PREVOST

Warranty Bulletin

96-09A

Subject: REINFORCEMENT OF THE EXHAUST PIPE AND ELECTRICAL

FIGURE 1 04001

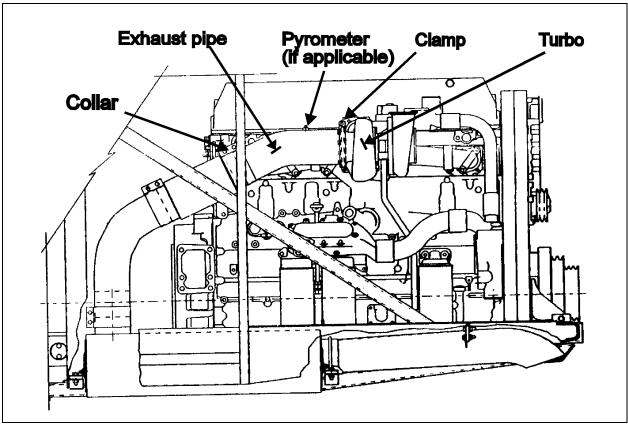
- 1. Open the engine compartment door(s).
- 2. Identify the first part of the exhaust pipe beside the turbo engine (Fig. 1).
- 3. Unscrew the clamp and the collar (Fig. 1).
- 4. Remove first part of the exhaust pipe and replace it by the new one.

5. Install the new clamp (Prévost # 540047) and the new collar (Prévost # 540024).

Note: To install the collar properly, screw the clamp and collar alternately in order to ensure airtightness. Refer to the maintenance manual section 04-3 for proper collar installation.

FIGURE 3: TOP VIEW OF REAR ELECTRICAL COMPARTMENT

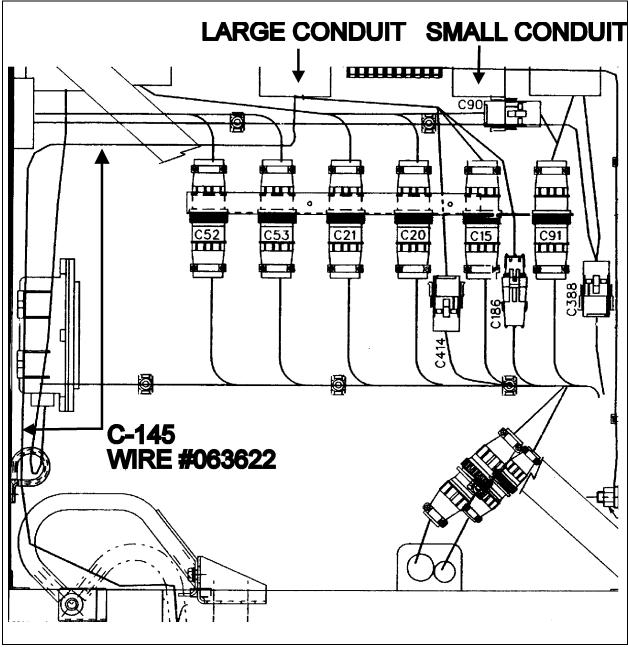
1. Locate connectors of both electrical conduits in rear electrical compartment (Fig. 3).

2. Disconnect connectors C-154, C-414, C-186, C-145 of the largest electrical conduit (Fig 3).

FIGURE 4: MIDDLE VIEW OF THE REAR ELECTRICAL COMPARTMENT

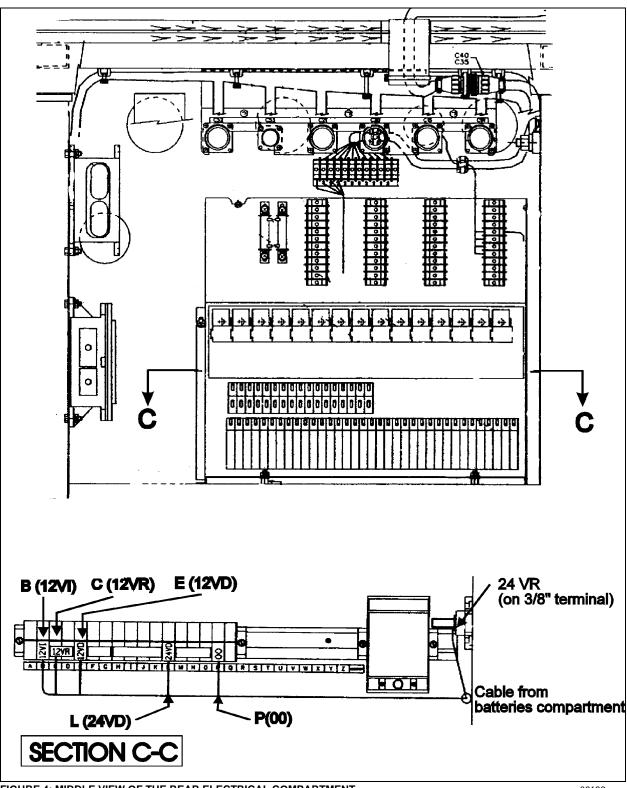
Disconnect wires 24VI, 12VI,12VR, 12VD, 24VD and 00. They are all for the smallest conduit. 3.

FIGURE 5: PANELS IN FRONT OF TRANSMISSION

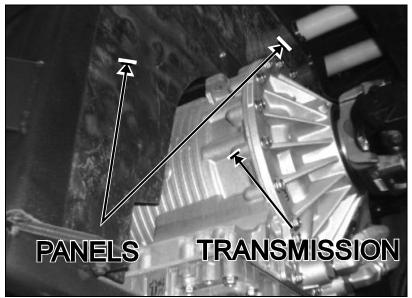
- 4. Remove all tie cables to make easier wiring harnesses removal.
- 5. Remove sealant around conduits in rear electrical compartment and in main power compartment.
- 6. Lift vehicle at the recommended jacking points as outlined in section 18 of your maintenance manual.
- 7. Place safety supports underneath body.
- If your vehicle does not have a retarder, take place on R.H. side of transmission, in the empty space and locate the two conduits. Use a step to reach conduits.
- 9. If your vehicle has a retarder or a manual transmission, take place in front of the transmission, in empty space and locate front panels (Fig. 5). Remove one panel to access electrical conduits.

FIGURE 6: TOP VIEW OF ELECTRICAL CONDUITS

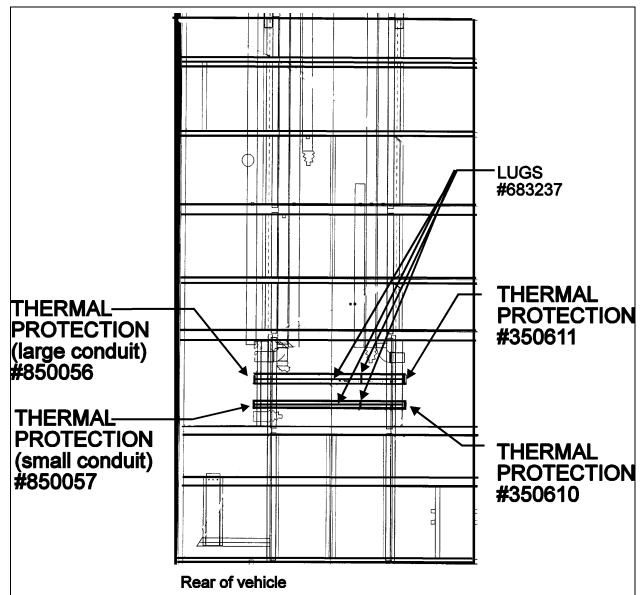
- 1. Lift vehicle at the recommended jacking points as outlined in section 18 of your maintenance manual.
- 2. Place safety supports underneath body.
- 3. If your vehicle does not have a retarder, take place on R.H. side of transmission, in the empty space and locate the two conduits. Use a step to reach conduits.
- 4. If your vehicle has a retarder or a manual transmission, take place in front of the transmission, in empty space and locate front panels (Fig. 5). Remove one panel to access electrical conduits.
- 5. Remove tie cables.
- 6. Cover large electrical conduit with thermal protection (Prévost # 850056) on the L.H. side and thermal protection (Prévost # 350611) on the R.H. side (Fig. 6).
- 7. Cover small electrical conduit with thermal protection (Prévost # 850057) on the L.H. side and thermal protection (Prévost # 350610) on R.H. side (Fig. 6).

- 8. Stick lugs (Prévost #683237) to close and join both thermal protections (Fig. 6).
- 9. Install tie cables (Prévost #504637) every 8 inches on both thermal protections. For the largest electrical conduit, use two tie cables to get around.
